# STONE'S WAREHOUSE SR-23-2015

## Administrative Action Administrative Site Review

**Case File / Name:** SR-23-15 / Stone's Warehouse

SR-23-15 Preliminary Site Plan

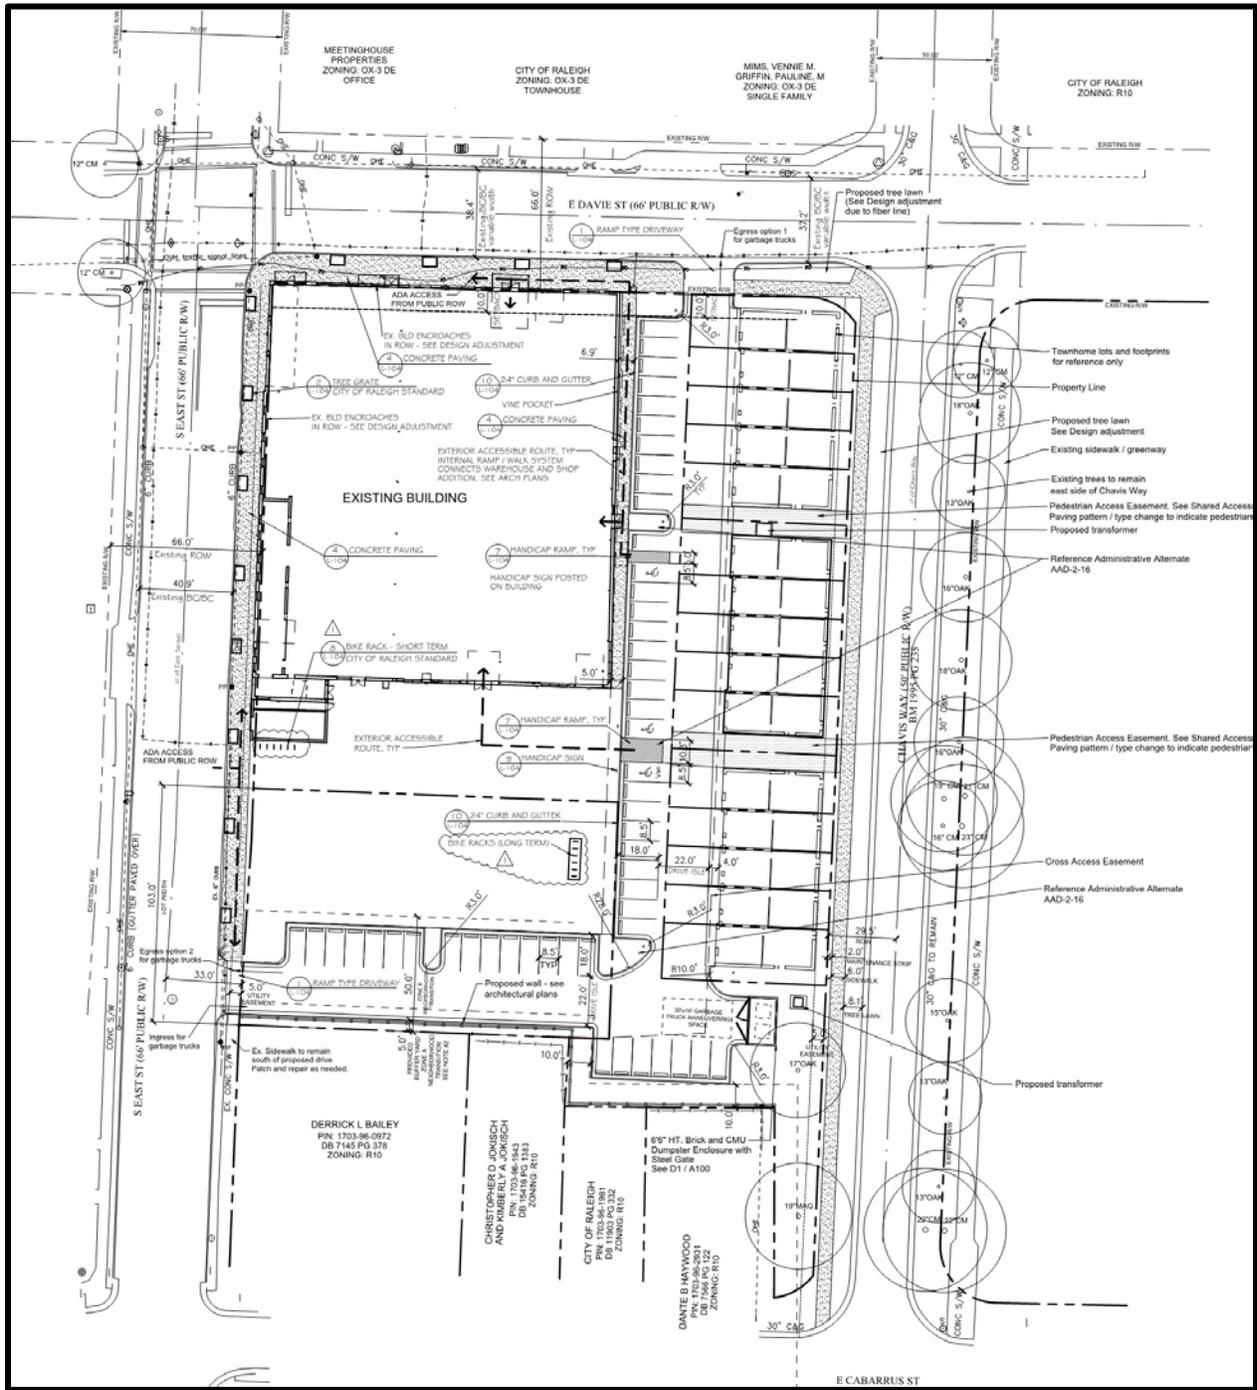
**Request:** Development of a 1.12 acre tract (Lot 1, S-12-16) and a .378 acre tract (Lot 2, S-12-16) zoned IX-3-UL-CU. Lot 1 includes the renovation and repair of an existing 26,902 square foot general building type for retail and light industrial uses. Lot 2 will be a 15 space remote parking facility, with room for future development.

<b>Code Conformance:</b>		<b>Code Section(s)</b>
<b>Zoning District:</b>	IX-3-UL-CU (See attached for zoning conditions).	<a href="#">2.1</a> , <a href="#">3.1</a>
<b>Overlay District:</b>	N/A	<a href="#">5.1</a>
<b>Parking:</b>	34 spaces required based on 1/500 square feet GFA, 36 provided on lot 1. Lot 2 will provide 15 additional spaces.	<a href="#">7.1.2</a>
<b>Street Type(s):</b>	E Davie St: Avenue 2-lane, undivided S East St: Neighborhood Street Chavis Way: Neighborhood Local  See S-12-16 for right-of-way dedication and design adjustments.	<a href="#">8.4</a>
<b>Streetscape:</b>	Mixed-Use streetscape. A Design Adjustment has been approved to allow a 10' sidewalk along the entire frontage of S East Street.  See S-12-16 for Design Adjustment for other Design Adjustments.	<a href="#">8.5</a>
<b>Setbacks/Frontage:</b>	There is an Urban Limited (UL) Frontage on this property. This approval is for the renovation and repair of an existing building. No new buildings are proposed. A Design Adjustment was approved with S-12-16 to allow the existing building to encroach into the right-of-way of E Davie and S East Streets.	<a href="#">3.4</a> , <a href="#">3.2</a> , <a href="#">2.2</a>

<b>Neighborhood Transitions:</b>	Required against the adjacent residentially zoned properties to the south. The transitions are provided in accordance with Article 3.5 except in those areas where changes were approved by the Board of Adjustment with cases A-97-16 and A-98-16. These include the elimination of the transition area near the southeast corner of lot 1 and the reduction of zone A to 5' for a portion of the southern property line of lot 2.	<a href="#">3.5</a>
<b>Transitional Protective Yards:</b>	N/A; not required for this use.	<a href="#">7.2.4</a>
<b>Stormwater:</b>	This site is subject to stormwater management controls in accordance with Article 9 chapter 2 of the Unified Development Ordinance. Proposed stormwater control measures were approved with the subdivision of the property (S-12-16).	<a href="#">9.2</a>
<b>Tree Conservation:</b>	This site is less than two acres in size and therefore exempt from Article 9.1, Tree Conservation.	<a href="#">9.1</a>

<b>Variances, Design Adjustments, Administrative Alternates:</b>	<u>A-97-16, A-98-16</u> (See Neighborhood Transitions section) <u>AAD-2-16</u> : Alternate to 7.1.7, <i>Vehicle Parking Lot Landscaping</i> , to allow alternate location of shade trees. Design Adjustments (See S-12-16 and Streetscape section)	
<b>Other:</b>	N/A
